PLANNING COMMISSION MEETING AGENDA REGULAR MEETING

January 8, 2013

5. PUBLIC HEARING – CONDITIONAL REZONING APPLICATION (File Number CR 008) – Proposed Tim Horton’s Café, Northwest Corner Square Lake and Dequindre, Section 1, From NN (Neighborhood Node “N”) to CB (Community Business) District

Conditional Rezoning, Special Use Permit and Preliminary Site Plan Review For City of Troy, Michigan

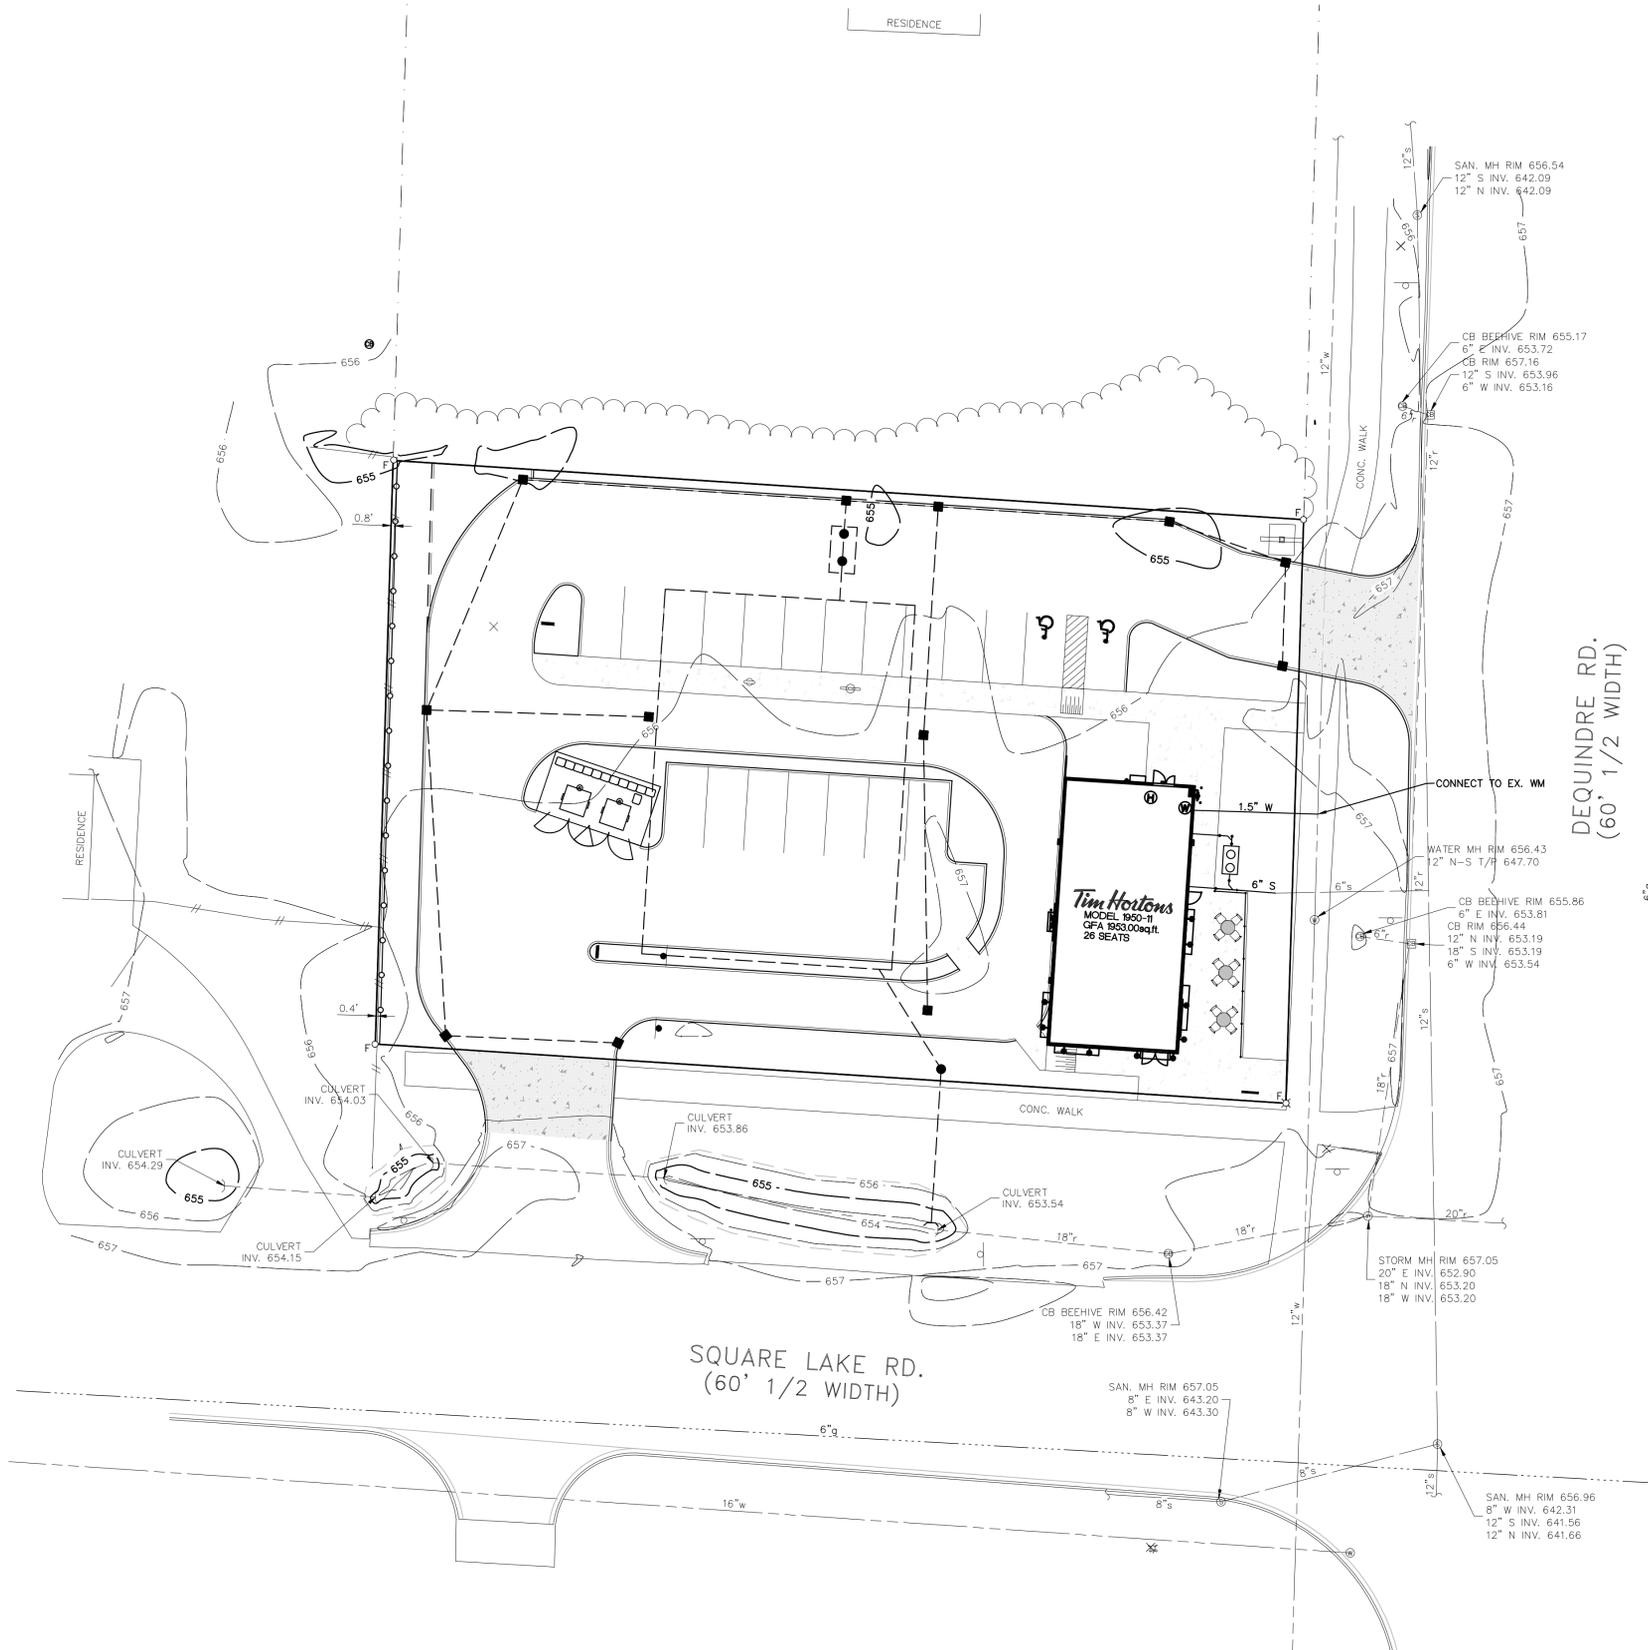
Parking, traffic, and circulation for this site must be carefully examined. The Engineering Department has requested a traffic study to review the need for a deceleration lane on Square Lake, internal circulation, and potential for restricting left turns in and out of the site. The other Tim Horton locations that have been built in Troy have been on higher volume roads including Big Beaver and Rochester (both 6-lane boulevards) and Maple (5-lane road which required that they provide a right turn lane or at least infill the one that stopped short of the existing site). In addition, Dequindre is a County border road, so any work in the Dequindre ROW or impact from the development on Dequindre may need input/permits from Sterling Heights/Macomb County/Oakland County.

Access to the site will be via a curb cut off Square Lake and a curb cut off Dequindre. The Engineering Department notes that both approaches are irregularly shaped. The applicant should try to reconfigure the approaches so that they enter the property perpendicular to the property line and then provide the necessary radii to match up to the parking lot. This would result in a more typical parking lot layout.

The applicant is deficient by eight (8) parking spaces. The Planning Commission may reduce the required parking provided that the applicant provide evidence that such parking is not necessary. The approved Maple Road Tim Hortons was exactly the same square footage and provided 22 spaces.

The applicant did not provide a Photometric Plan, as required.

Based on a 0.68 acre site, the applicant is required to provide 592 sq/ft of landscaped area. The applicant should confirm if they have met this requirement. The applicant should indicate on site plan where snow storage is proposed. Lastly, the applicant should provide trash enclosure details; the applicant is encouraged to match the enclosure materials with the masonry of the building.

Items to be Addressed: 1). Provide traffic study prior to Planning Commission recommendation of Conditional Rezoning and Preliminary Site Plan approval; 2). Reconfigure the approaches so that they enter the property perpendicular to the property line; 3). Reduce drive-through width to 10 feet; and 4). Reconfigure layout so that the tenth required stacking space does not protrude into drive-aisle.

Items to be Addressed: Provide 8 additional spaces, or provide evidence that providing only 18 spaces is sufficient to address site parking needs.

Items to be Addressed: Provide a Photometric Plan in compliance with Article 13.

Items to be Addressed: 1.) Provide overall landscaping calculation; 2.) Replace ornamental trees with deciduous ones along Square Lake; and 3.) Provide one (1) additional parking lot tree; 4.) Indicate on-site snow storage; and 5.) Provide trash enclosure detail.

10. Amend Section 4.14 to replace the existing graphic with the following graphic:

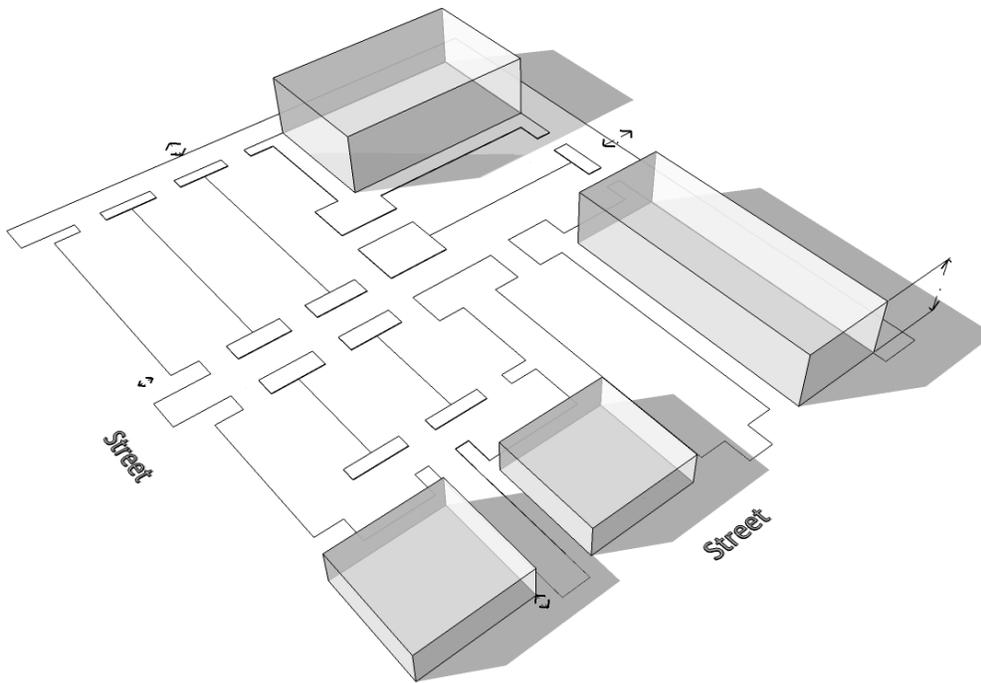
- Section 4.14 Graphic (page 75):** Amend graphic to include an additional building mid-block (no substantive change to regulations). New Graphic:
